Ossipee Aquifer Advisory Committee
c/o GMCG P.O. Box 95 Effingham, NH 03882
(603) 539-1859

On behalf of the Ossipee Aquifer Advisory Committee, please accept this letter detailing our concerns over the proposed groundwater discharge plan for Pinetree Power outlined in the Groundwater Discharge Permit Application Id# 199407004 dated 6/28/2019.

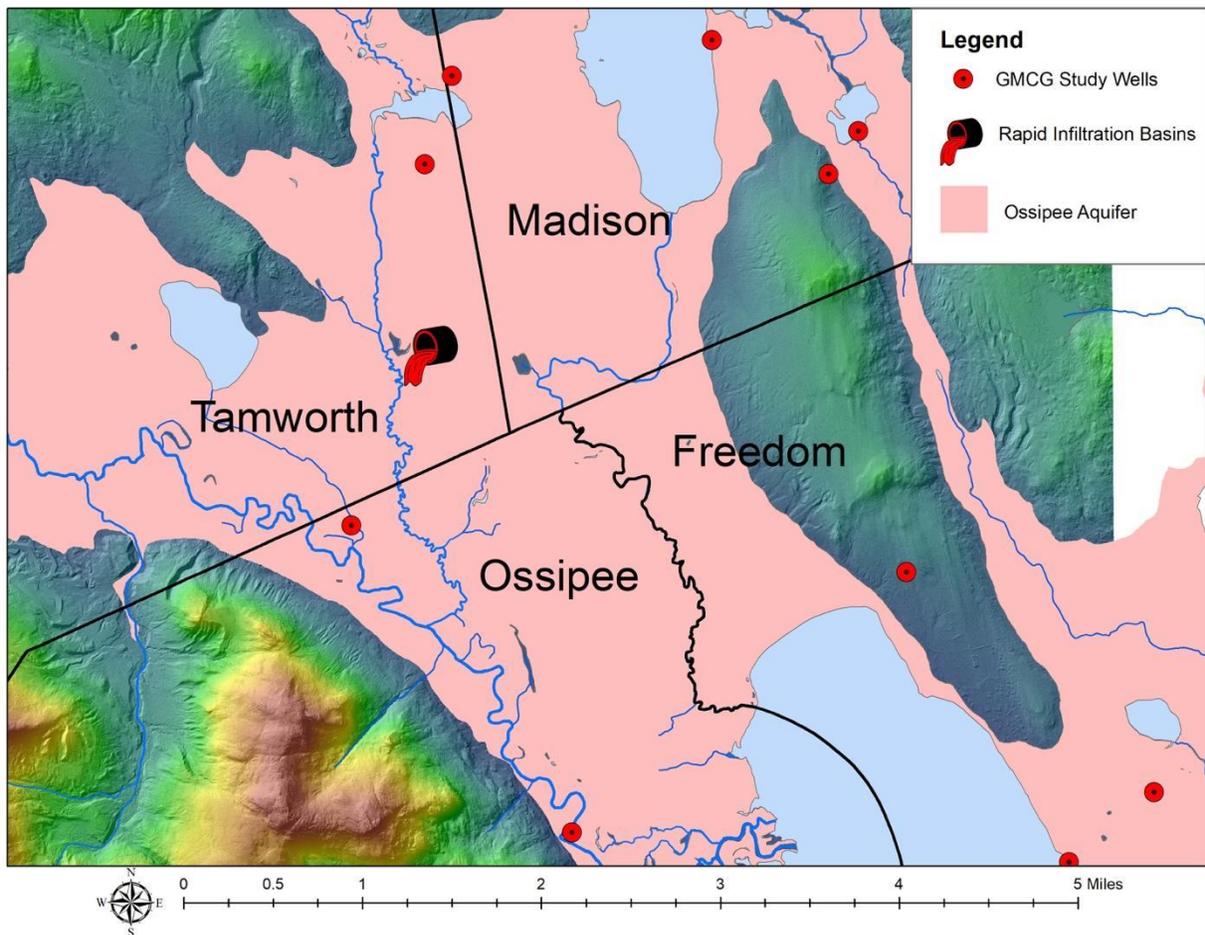
The Ossipee Aquifer Advisory Committee supports efforts to maintain the quality and quantity of groundwater within the Ossipee Aquifer system. Our mission is to work, in an advisory capacity, with local municipalities, agencies, boards and commissions to gather information and comment on developments that may impact groundwater in the region. The Ossipee Aquifer is the largest stratified drift aquifer in the State of New Hampshire (Moore and Medalie, 1995) and, as it crosses municipal boundaries, we seek to coordinate efforts across multiple municipalities. The coarse sands and gravels that make up much of this aquifer make it highly transmissive and susceptible to contamination. The majority of residents in the towns of Tamworth, Madison, Ossipee, Freedom and Effingham depend on this aquifer for their drinking water. In addition, the Ossipee Aquifer discharges directly into Ossipee Lake as well as into numerous tributary streams that feed the Saco River where more than 300,000 people in Saco and Biddeford draw their drinking water. The proposed project at Pinetree Power is located in the heart of this Aquifer (Figure 1).

Even worse, Pinetree Power’s proposed Rapid Infiltration Basins (RIBs) lie just outside the Well Head Protection Area (WHPA) of the Tamworth Pines Public Water System (PWS) (Id#2313020) that supplies water to over 100 people. Some of the RIBs are less than 100ft from the WHPA and the groundwater gradient determined during the RIB tests showed groundwater flowing directly toward the WHPA. It is therefore likely that the wastewater brine dumped into the RIBs will be drawn into the Tamworth Pines supply wells resulting in their contamination. Consequently, Pinetree Power’s proposal to change their disposal practices to RIBs represents a direct, deleterious threat to water quality, that will likely result in contamination of large areas of the aquifer; including public water supply wells. We strongly object to this change in disposal practices and urge you to deny this permit in order to protect the health and safety of the area’s drinking water resources, upon which New Hampshire residents, businesses and the local economy depend.

Figure 2. The RIBs lie within the area that is most susceptible to groundwater contamination.

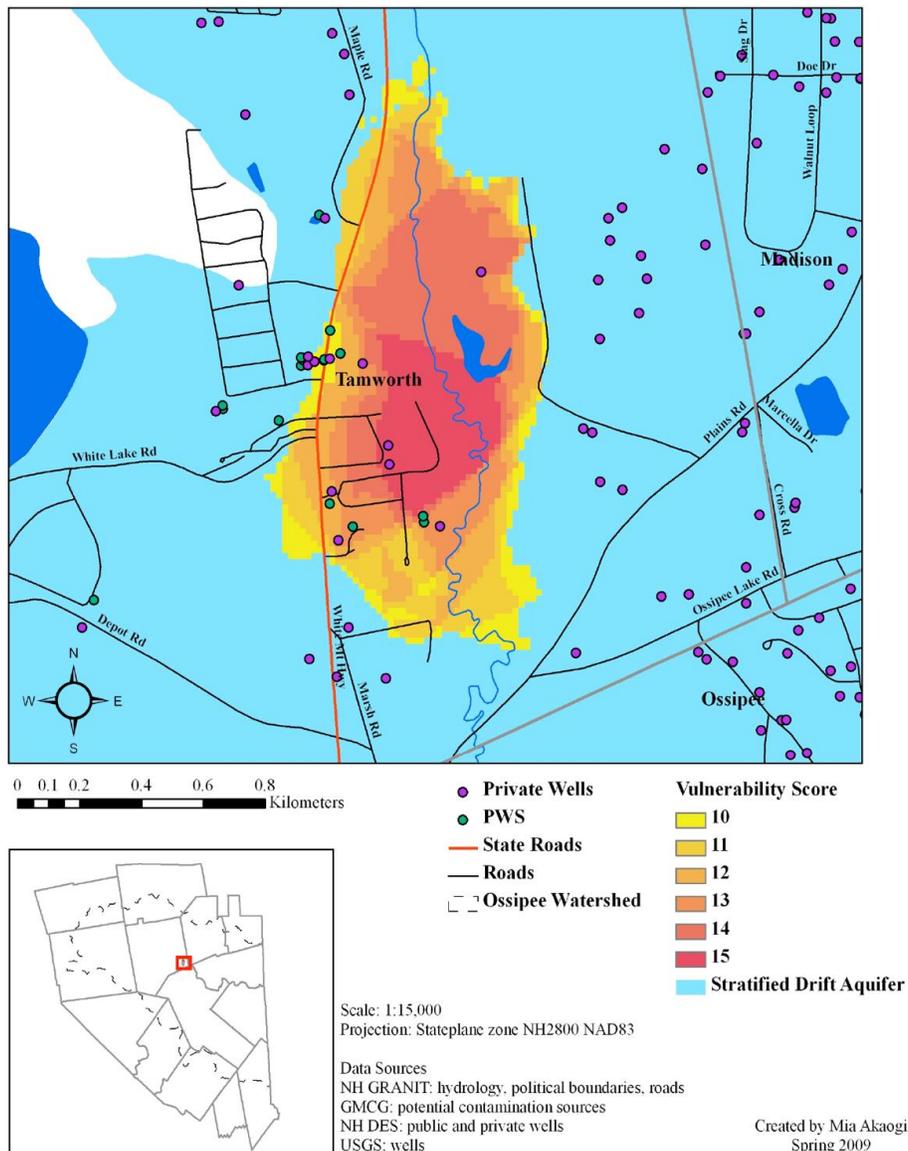
1. A 2009 study done by Mia Akaogi, as part of her masters degree in the Rubenstein School of Environment and Natural Resources at the University of Vermont identified the area, where the proposed RIBs are to be located, as being the most vulnerable to groundwater contamination in the Ossipee Watershed (Figure 2)(Akaogi, 2009). This is the worst possible location for any wastewater discharge.

Figure 3. Bar graph comparing ambient groundwater (Aquifer) with diluted circulation water. Ambient concentrations are so low as to barely be visible on the graph.

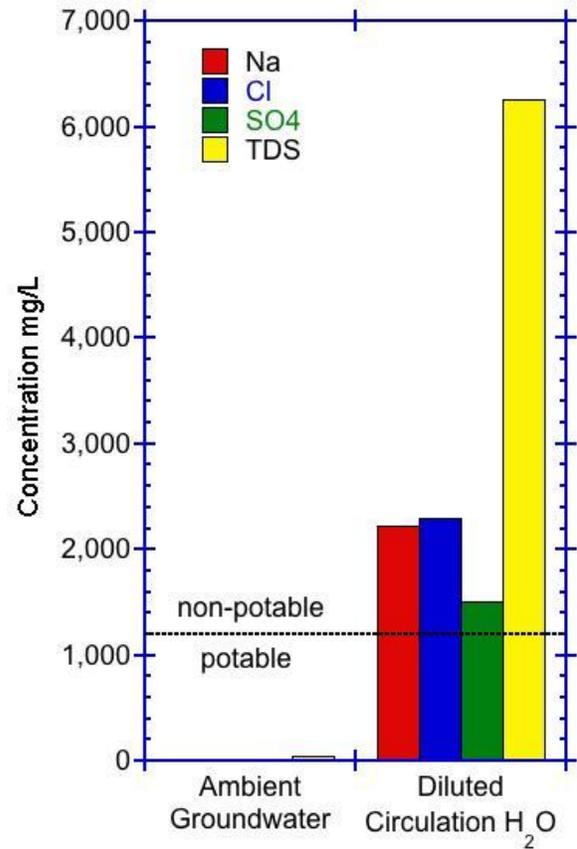
The combined results from these studies provide a base line to evaluate the impact of the proposed RIBs. They show that the average TDS value for wells that lie within the stratified drift aquifer in the vicinity of the power plant is 49 mg/L compared to a value over 25,000 mg/L for the circulation water (9/27/17) and 6,250 mg/L after a 1 in 4 dilution (1 part wastewater, 3 parts ambient groundwater). The average chloride value of the ambient groundwater is 4.4 mg/L compared to 9,200 mg/L in the wastewater and 2,300 mg/L in the diluted water (Figure 3; Table 2). It is clear from this analysis that wastewater infiltration through the RIB's will have a dramatic negative impact on water quality. The ambient groundwater will go from a nearly pristine condition with an average specific conductance of 79 $\mu\text{S}/\text{cm}$ to a highly mineralized brine with a specific conductance of 11,700 $\mu\text{S}/\text{cm}$ and a TDS of 6,250 mg/L which is almost 6 times higher than the maximum value for potable water.

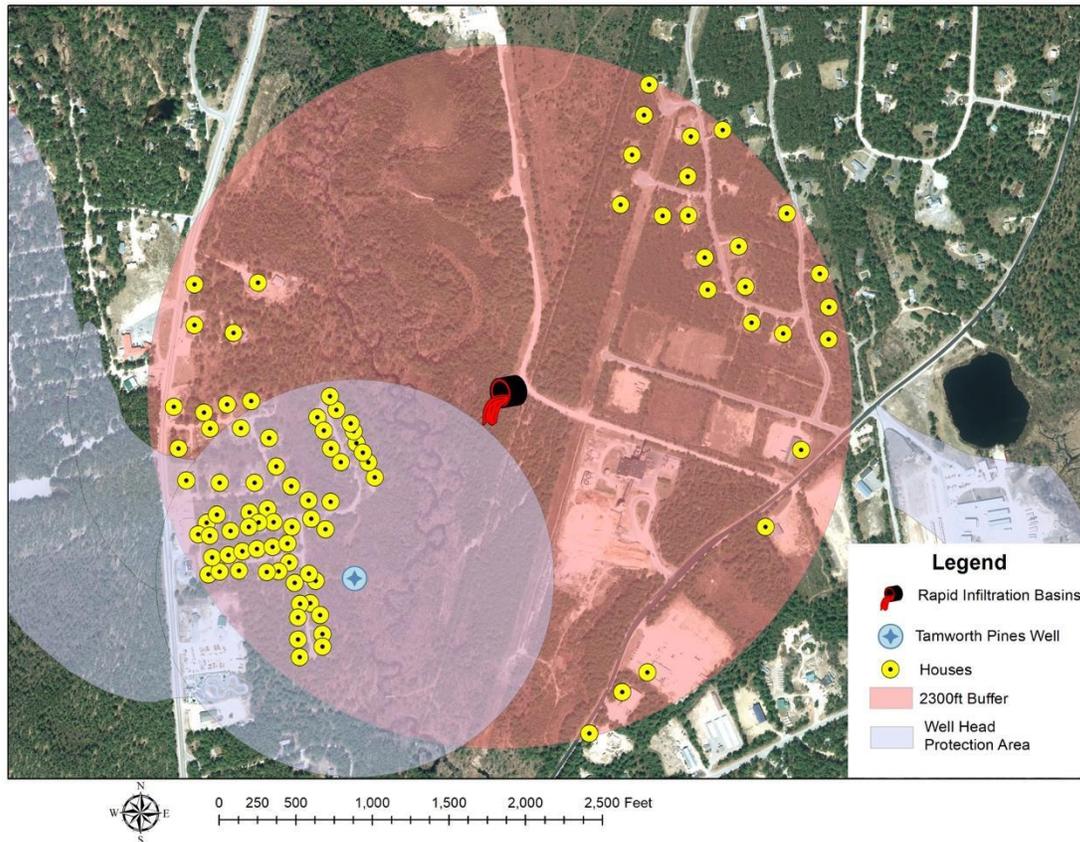
- The permit is for a staggering 100,000 gallons per day of wastewater infiltration. To get a better understanding of the scale of this impact on the aquifer here is a simple conceptual volume exercise. 100,000 gallons is equivalent to approximately 13,300 cubic feet of water. Assuming that the aquifer has a porosity of 0.3 and no specific retention, then this volume would saturate 44,300 cubic feet of the aquifer with wastewater. If we assume that this would cause the water table to rise one foot and that the water would spread in a circular pattern (it would actually be elongated along the groundwater flow line) then the radius of the circle would be 118 ft. With 100,000 gallons being infiltrated daily, this circle would

expand to almost 2,300 ft in one year. Throughout that area, the wastewater would be 1ft thick. Figure 4 shows where this circle lies on an air photo of the region.

Over 90 homes and businesses lie within this zone (represented by yellow dots). This is clearly a conceptual exercise, but it demonstrates that a huge volume of undrinkable water will be infiltrated into the aquifer and it will clearly spread to areas with both public and domestic wells. The ultimate extent of the contamination is difficult to predict. Given its density, the wastewater plume may sink to the bottom of the aquifer where its movements could be controlled in part by the bedrock surface topography. It is also possible that differences in temperature between the wastewater and the ambient groundwater could influence the direction of flow. Dilution of the plume by the surrounding groundwater will be limited, given that groundwater flow in surficial aquifers is laminar and the only mechanisms for dilution are diffusion and dispersion. Given the volume of the plume, the central portion will be essentially undiluted for a long distance downgradient. The high transmissivity (27,000 gal/dayft) of the aquifer in this area means that the plume will move far and fast. It will mainly go westward, towards the Chocorua River. Some wastewater will undoubtedly enter the stream, negatively impacting stream water chemistry, but the river is

not fully penetrating and much of the wastewater will move under the stream and will likely contaminate the Tamworth Pines PWS. Thus, if permitted, the disposal of this waste will end up contaminating both domestic and PWS wells, as well as reducing the water quality of streams draining into Ossipee Lake.

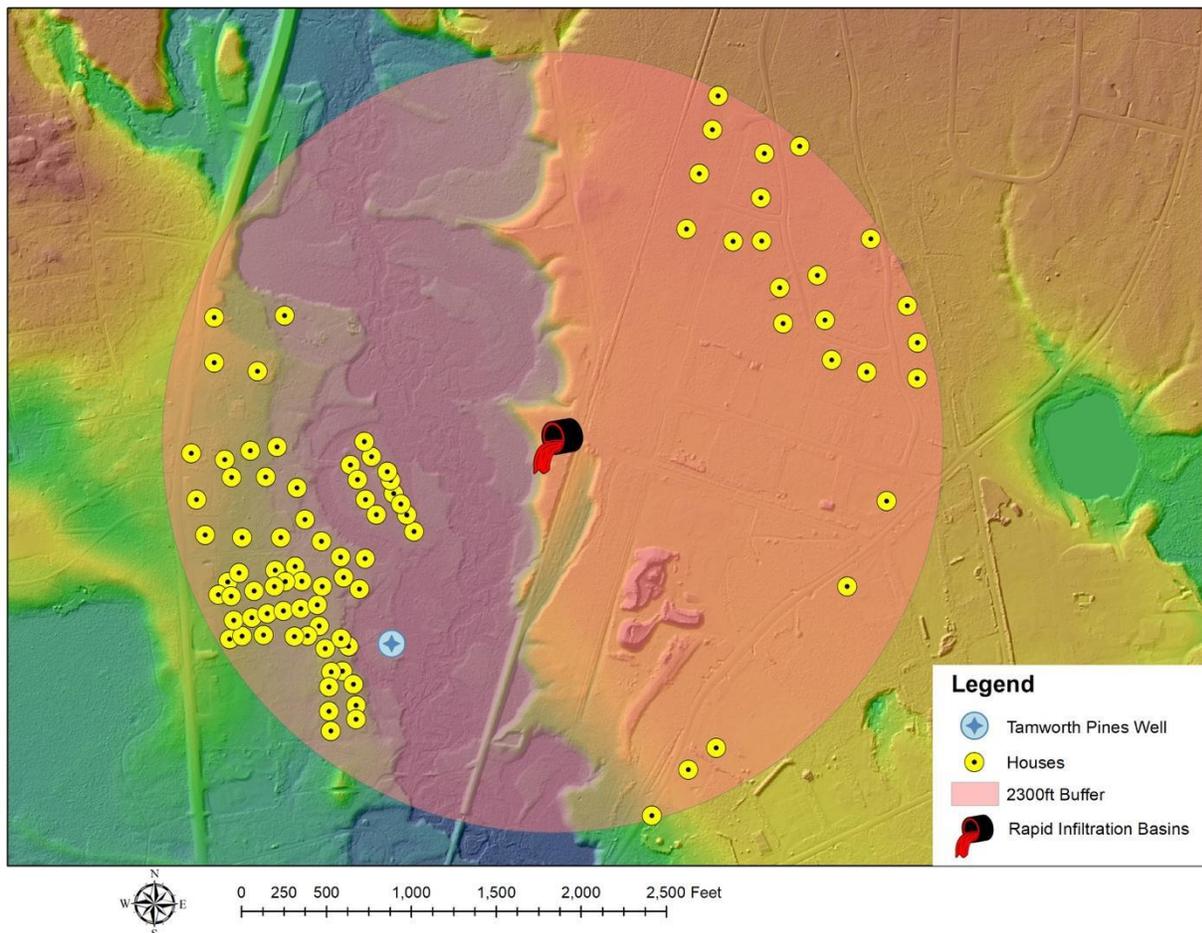
9. The Tamworth Pines PWS wells are most vulnerable to contamination and immediate efforts should be made to monitor their chemistry as they lie just over 1000 ft from the RIBs (Figure 5). Approximately 1 million gallons of wastewater was added to the aquifer during the time the temporary permit was in force (January-April 2019). This wastewater occupies almost half a million cubic feet of the aquifer and represents a potential threat to all nearby wells. Tamworth Pines PWS needs to be notified so that they can begin a chemical monitoring program to detect the possible approaching plume of contamination. This monitoring should include analyses for stable water isotopes ($\delta^{18}\text{O}$ and $\delta^2\text{H}$) as the cooling tower wastewater has a unique isotopic signature (highly enriched in $\delta^{18}\text{O}$ and $\delta^2\text{H}$) that will be easy to identify (Ingraham, et al., 1994).

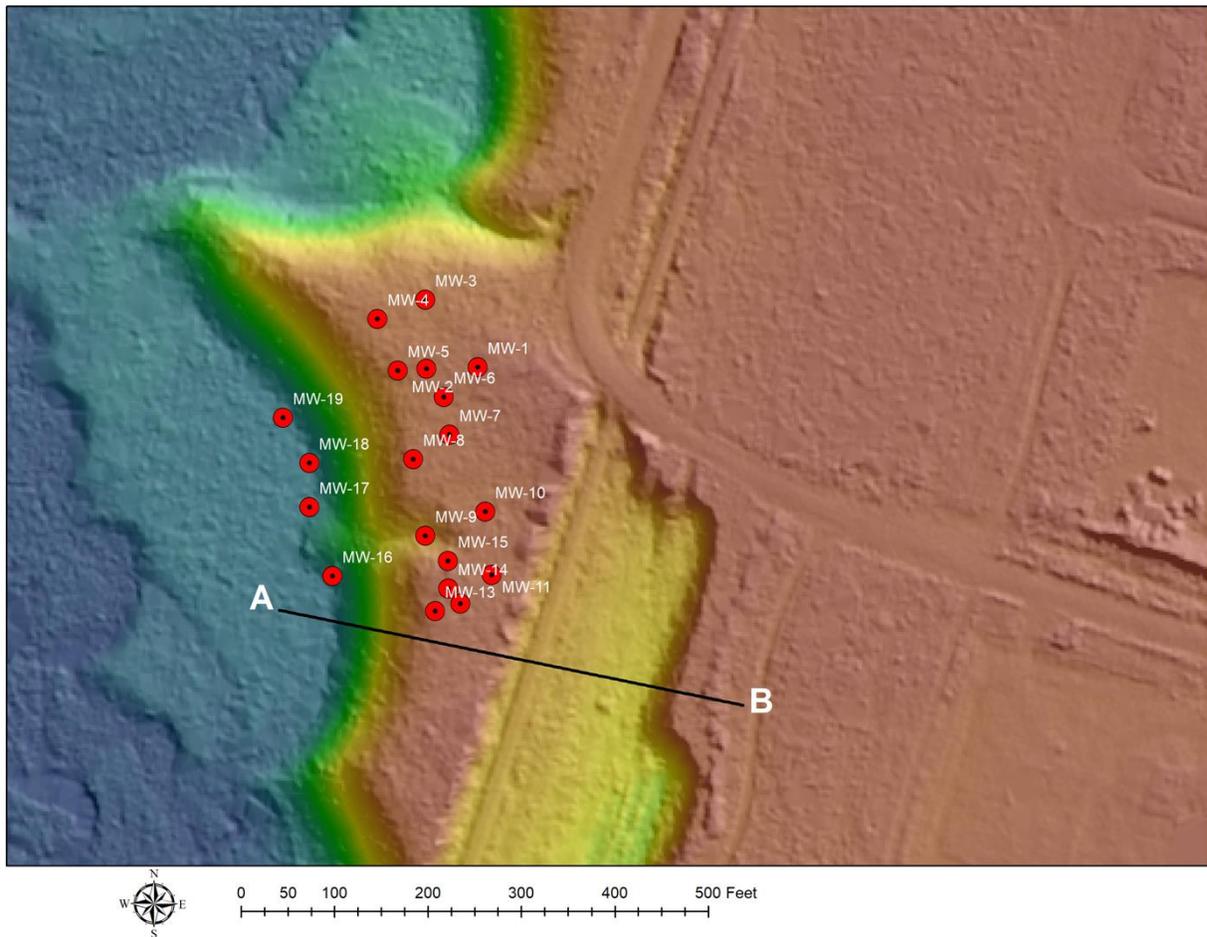
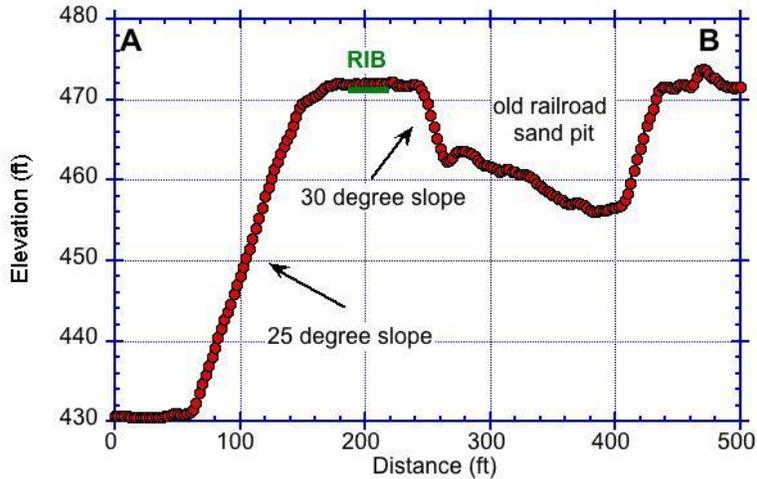
10. The RIBs are located next to steep, 25+ degree slopes that drop over 40ft to the floodplain of the Chocorua River to the west and over 10ft to the abandoned sand pit to the east (Figure 5a and b). The concern here is that hydraulic loading could, under the right soil moisture conditions, lead to a slope failure either westward to the Chocorua River or eastward to the abandoned sand pit. It is worth noting that there are two channels shown on the LiDAR Digital Elevation Model (DEM) that dissect the slope edge (Figure 2). Both have small alluvial fans at their base and are likely the result of groundwater sapping during periods of high groundwater stage.
